SUBJECT: TRIP REPORT - NAS COMMITTEE MEETING TO REVIEW SURFACE PROCESS  
TECHNICAL BASIS REPORT, LAS VEGAS, NV, 7/19 & 7/20/95

**NRC STAFF REVIEW OF DOE TOPICAL REPORT  
ON EXTREME EROSION**

**COMMENTS TO THE NAS YUCCA MOUNTAIN PEER REVIEW PANEL ON  
SURFACE PROCESSES**

## **NRC CONCERNS**

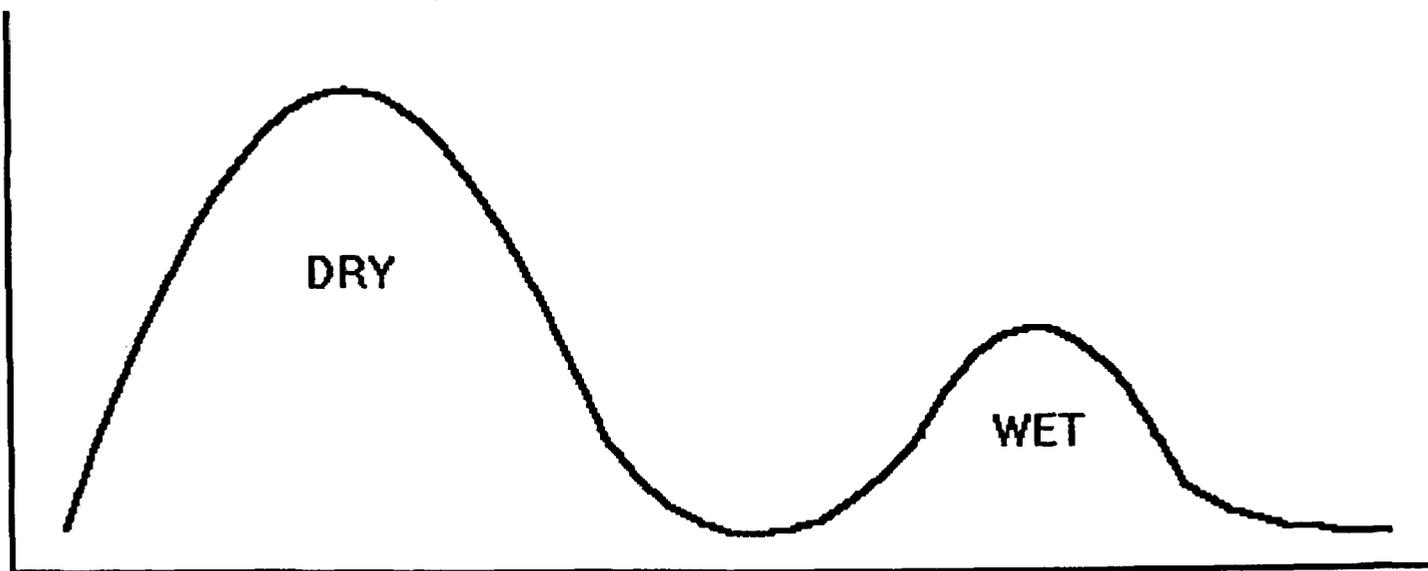
- **STAFF CONCERN WITH THE SCOPE OF THE TOPICAL REPORT**
- **ADEQUACY OF THE DATING METHOD NOT DEMONSTRATED**
- **DEFICIENCIES IN THE DATA QUALIFICATION PROCESS**

- **REGULATORY REQUIREMENTS RELATED TO EXTREME EROSION HAVE NOT BEEN MET**
- **TOPICAL REPORT FOCUSES ON DENUDATION RATHER THAN EXTREME EROSION**
- **DENUDATION" DEFINED AS THE WEARING DOWN OF THE EARTH'S SURFACE SIMULTANEOUSLY BY VARIOUS NATURAL PROCESSES, ONLY ONE OF WHICH IS EROSION**
- **TOPICAL REPORT DESCRIBES DENUDATION RATES AVERAGED OVER LONG PERIODS OF TIME ENCOMPASSING SEVERAL, PROBABLY MANY, CYCLES OF HILLSLOPE AGGRADATION AND DEGRADATION (EROSION)**

- **THE TERM "EXTREME EROSION" DEFINED IN NUREG-0804 (p. 382) AS "SUBSTANTIAL CHANGES IN LAND FORMS (AS A RESULT OF EROSION) OVER RELATIVELY SHORT PERIODS OF TIME**
- **RELATIVELY SHORT PERIODS OF TIME CONSIDERED EQUIVALENT TO "RELEVANT TIME PERIOD" AS DESCRIBED IN NRC'S TECHNICAL CRITERIA**
- **SCA COMMENT 43 OF 1989 INDICATES THAT AVERAGED LONG-TERM RATES OF EROSION ARE NOT CONSERVATIVE WHEN APPLIED TO SHORTER PERIODS SUCH AS THE PERIOD OF PERFORMANCE OF THE REPOSITORY**
- **DOE'S DENUDATION (DEGRADATION) RATES BASED ON AVERAGES OF TIME FRAMES RANGING FROM 170,000 TO 1.38 MILLION YEARS**
- **THESE RATES ARE NOT APPROPRIATE FOR PERIOD OF PERFORMANCE CONSIDERATIONS**
